# Mission Canyon Residential Design Guidelines Revised Draft Review

South Board of  
Architectural Review  
Presentation

February 15, 2008

**City of Santa Barbara**  
Design Districts

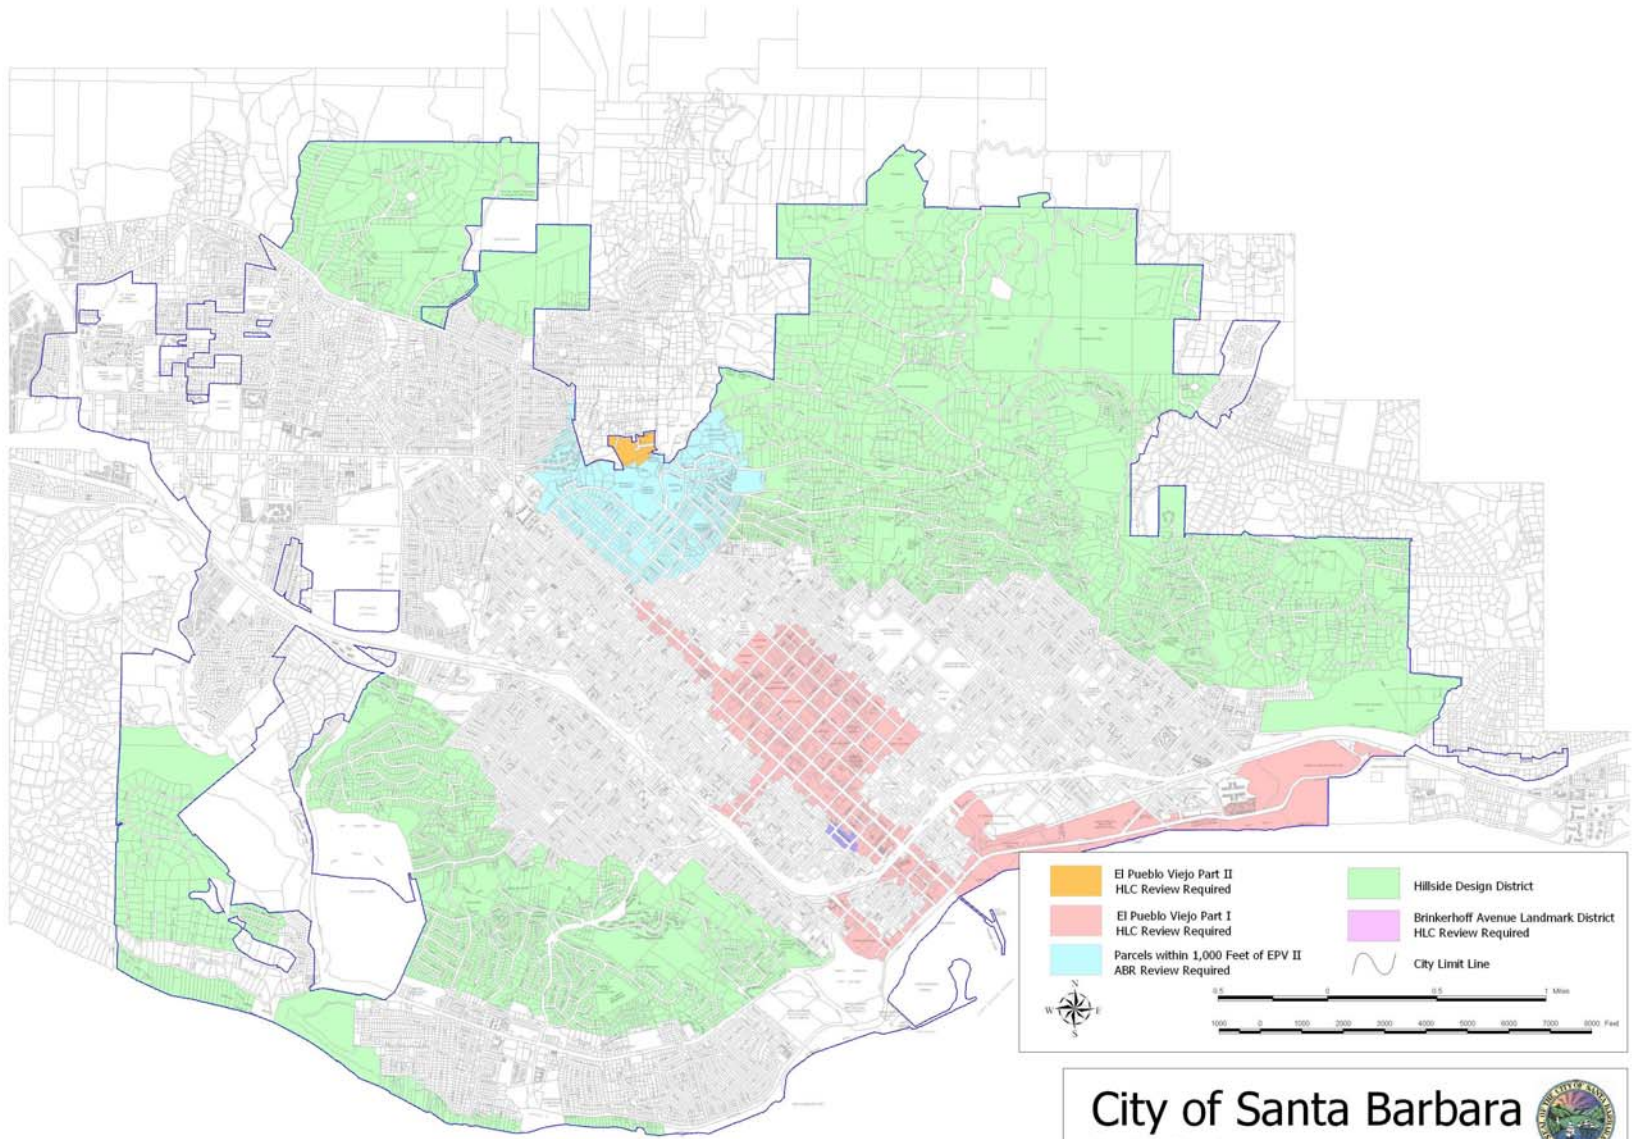
- ◆ Address compatibility with projects in the Vicinity (within 1,000 feet) of the Old Mission (City's El Pueblo Viejo District Part II)
  - Concerns about architectural quality and historic guidelines
